Access Compliance Report

Public Rights-of-Way

| Intersection ID: N/A | Main Street: GLENBURN_LN | Cross Street: N/A | Location: N |
| ADA ID: F0018E348465 | Ramp Type: Perp | Initial Pass/Fail: Fail | Overall Compliance: No |

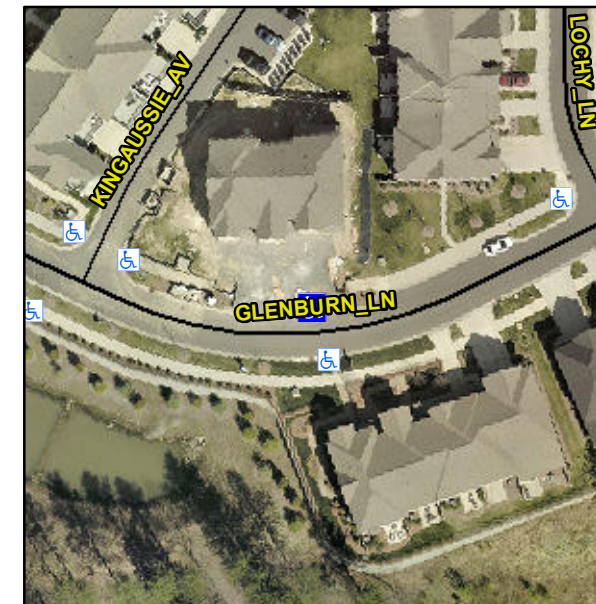
Remove & Replace Entire Ramp.

R304.5.1, R304.2.2, R304.5.3

| Compliance | Description | Data | Compliance | Description | Data |
|------------|-----------------------|------|------------|-----------------------------|------|
| N/A | Ramp Length (in) | 97.0 | No | Ramp Slope (%) | 8.4 |
| No | Ramp Width (in) | 47.0 | No | Ramp XSlope (%) | 3.2 |
